Access Compliance Report

Public Rights-of-Way

(Pedestrian Signals)

Intersection ID: N/A	Main Street:	Cross Street: N/A	Location: N/A
ADA ID: 0F856B990F5F	Signal Type: One Push Button-APS	Overall Compliance: No	Severity Score: BTN 1: N/A BTN 2: N/A No BTN: N/A
Codes/Mitigation Info/Possible Solution		Field Measurements/Component Compliance

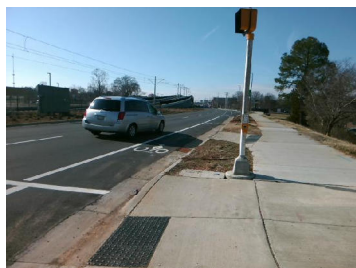
Compliance	Description	Data	Compliance	Description	Data
	Button Count	Button1	Yes	Distant to Additional Button (in)	308.0
	Additional Button Present?	Yes		Additional Button ID	D34CE5ECC6EA
N/A	Signal Buttons Required?	N/A	N/A	Additional Ped Posts Required	N/A
	How Many Ped Street Xings?	N/A		Located In An Island/Median?	N/A
N/A	B 1 Sign Present?	Yes	N/A	B 2 Sign Present?	N/A
Yes	B 1 Sign Purpose?	Yes	N/A	B 2 Sign Purpose?	N/A
Yes	B 1 Sign Lettering & Contrast?	Yes	N/A	B 2 Sign Lettering & Contrast?	N/A
Yes	B 1 Parallel To XWalk?	Yes	N/A	B 2 Parallel To XWalk?	N/A
Yes	B 1 PAR to Button?	Yes	N/A	B 2 PAR to Button?	N/A
Yes	B 1 PAR to XWalk?	Yes	N/A	B 2 PAR to XWalk?	N/A
Yes	B 1 Clear Floor Space?	Yes	N/A	B 2 Clear Floor Space?	N/A
N/A	B 1 FWD Approach?	No	N/A	B 2 FWD Approach?	N/A
N/A	B 1 FWD Approach Constrained?	N/A	N/A	B 2 FWD Approach Constrained?	N/A
N/A	B 1 FWD Approach Reach (in)	N/A	N/A	B 2 FWD Approach Reach (in)	N/A

N/A	B 1 FWD Approach Width (in)	N/A	N/A	B 2 FWD Approach Width (in)	N/A
N/A	B 1 FWD Approach Obstruction?	Yes	N/A	B 2 FWD Approach Obstruction?	N/A
N/A	B 1 FWD Approach Obstruction Dist (in)	4.0	N/A	B 2 FWD Approach ObstructionDist (in)	N/A
N/A	B 1 PARA Approach?	Yes	N/A	B 2 PARA Approach?	N/A
N/A	B 1 PARA Approach Constrained?	Yes	N/A	B 2 PARA Approach Constrained?	N/A
Yes	B 1 PARA Approach Reach (in)	10.0	N/A	B 2 PARA Approach Reach (in)	N/A
No	B 1 PARA Approach Width (in)	48.0	N/A	B 2 PARA Approach Width (in)	N/A
N/A	B 1 PARA Approach Obstruction?	Yes	N/A	B 2 PARA Approach Obstruction?	N/A
N/A	B 1 PARA Approach Obstruction Dist (in)	4.0	N/A	B 2 PARA Approach ObstructionDist (in)	N/A
No	B 1 Clear Floor Space Slope (%)	2.5	N/A	B 2 Clear Floor Space Slope (%)	N/A
No	B 1 Clear Floor Space XSlope (%)	3.3	N/A	B 2 Clear Floor Space XSlope (%)	N/A
N/A	B 1 PAR Slope (%)	N/A	N/A	B 2 PAR Slope (%)	N/A
Yes	B 1 Height (in)	38.0	N/A	B 2 Height (in)	N/A

Possible Solutions: Remove & Replace
Replace APS Button With New APS Button.
Remove and Replace Clear Space.
